Environmental Review Team Report

Baxter Road Condominiums

Willington Connecticut

July 1983

Surficial Geology

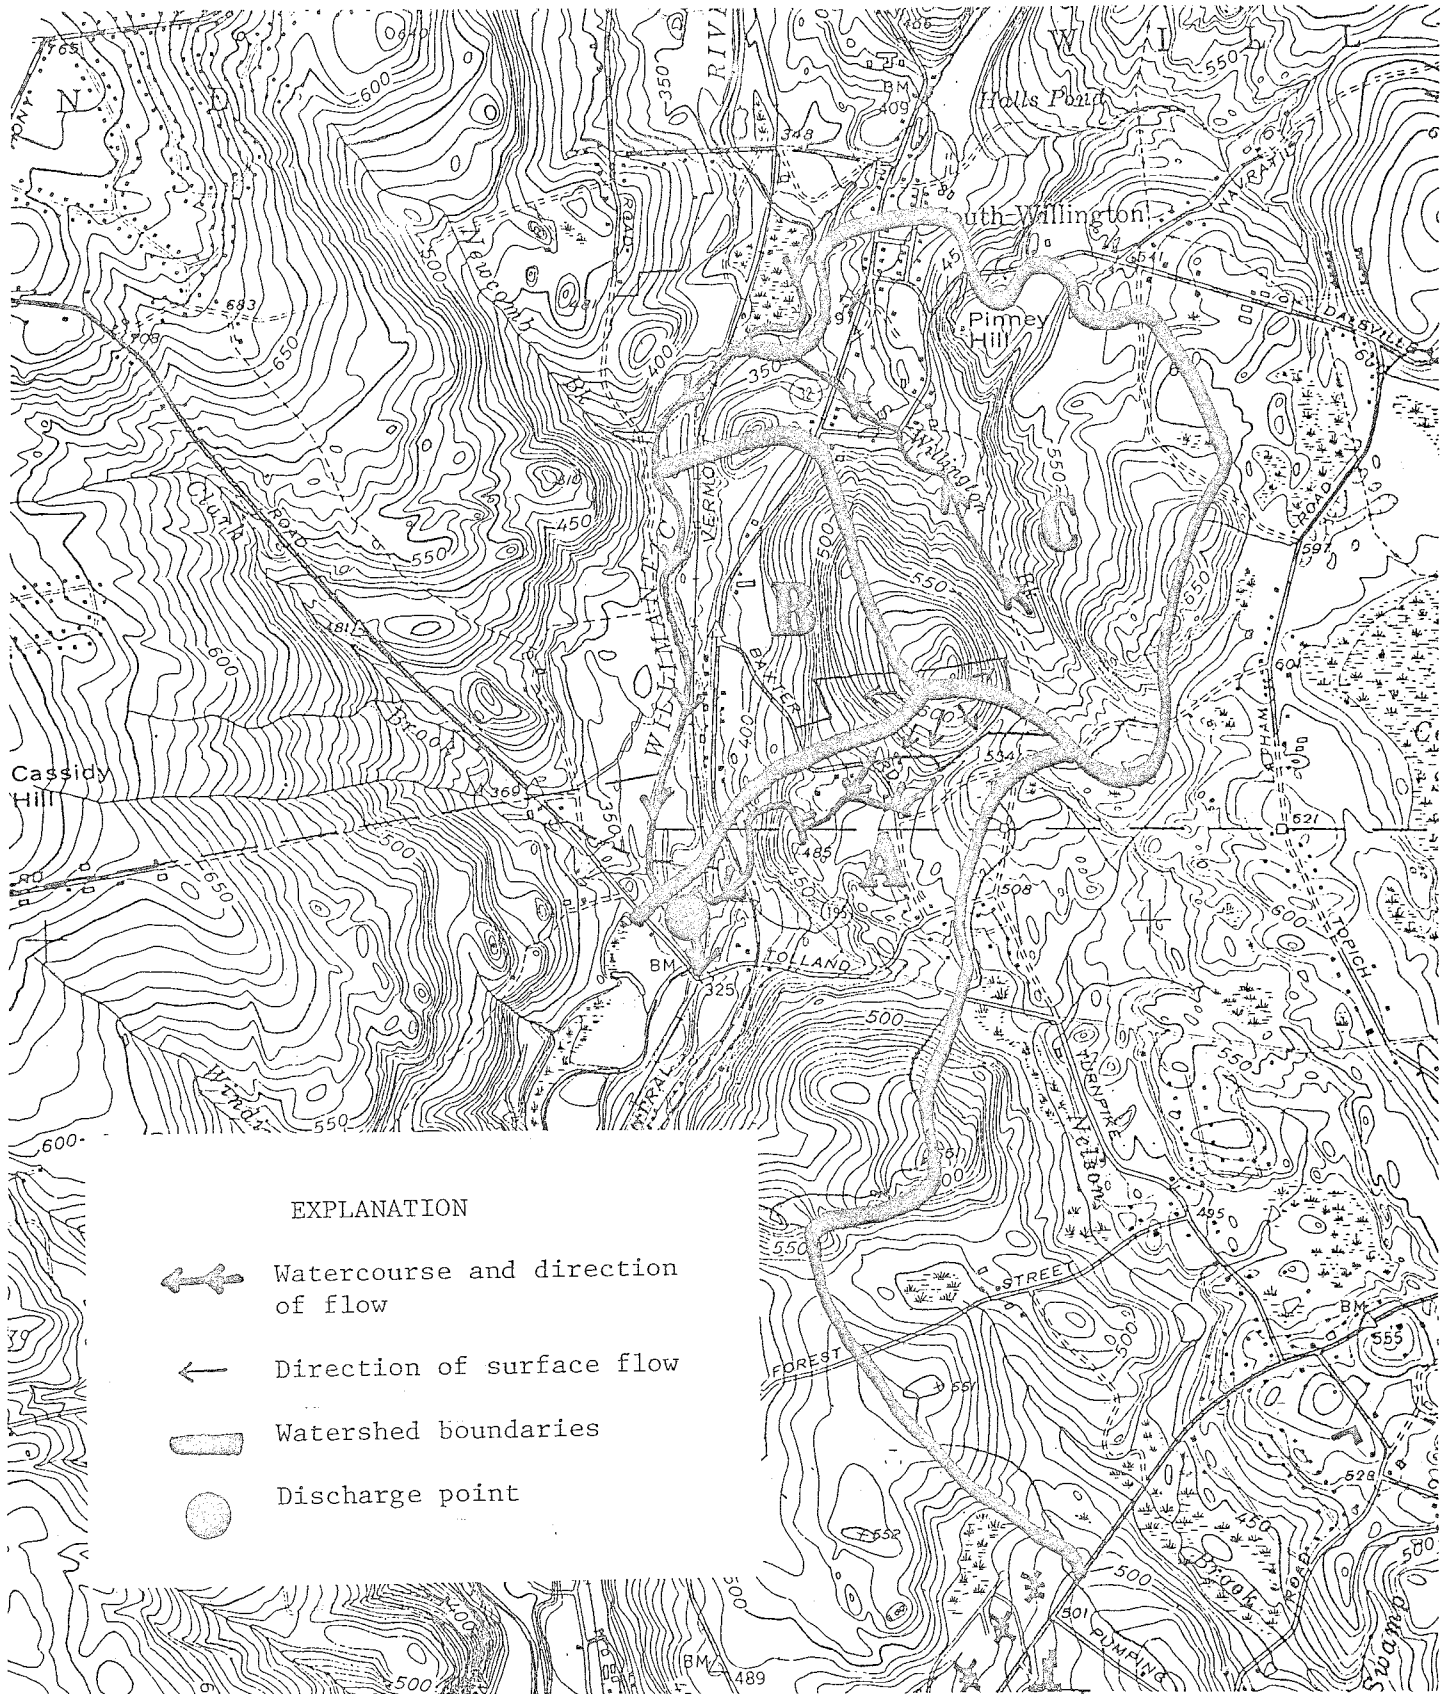
Another type of glacial sediment found on the study site is stratified drift. Stratified drift consists of sands and gravels that were deposited by glacial streams. This deposit is located throughout the southwest portion of the site where the primary and reserve on-site sewage disposal system is proposed. Thickness of these deposits is approximately 10 feet throughout this area.

In the southeastern and southern part of the site, primarily along the intermittent streams, till or bedrock is overlain by swamp deposits. Swamp deposits consist of silt, clay, sand and organic materials that settled to the bottom of a sluggish or stagnant water body.

Vegetation

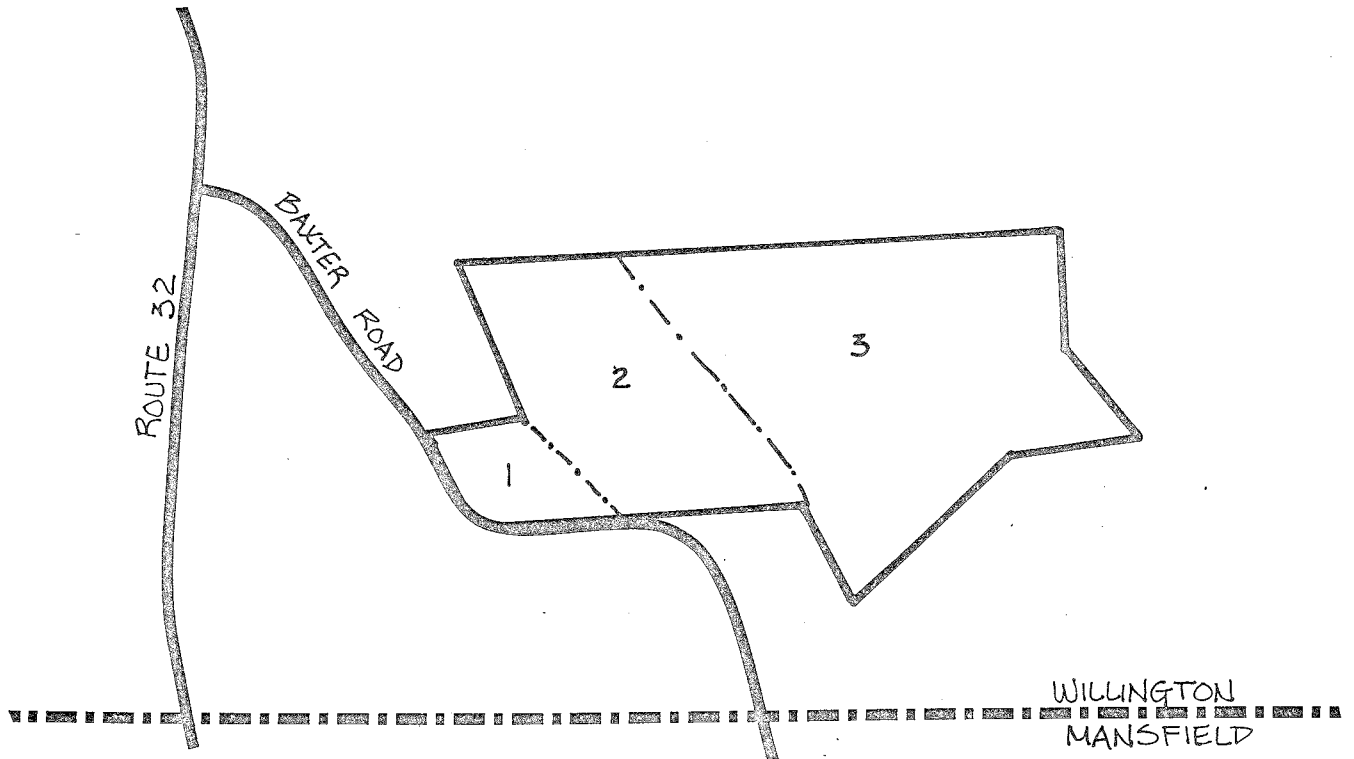
Large healthy trees and any flowering shrub present, especially in stand 2, should be considered for retention because of their high aesthetic value. The high risk trees, present in stand 2 should be removed prior to development to prevent windthrow after roads and buildings are present. Improvement thinnings in stands 2 and 3 prior to development would reduce crowding, remove high risk trees, result in a healthier, more stable forest over time and produce some revenue.

Many of the large, healthy red oak and white pine in stand 2 have high aesthetic and shade value. The high value trees should be selected for retention and worked into the final site plan for the proposed development.
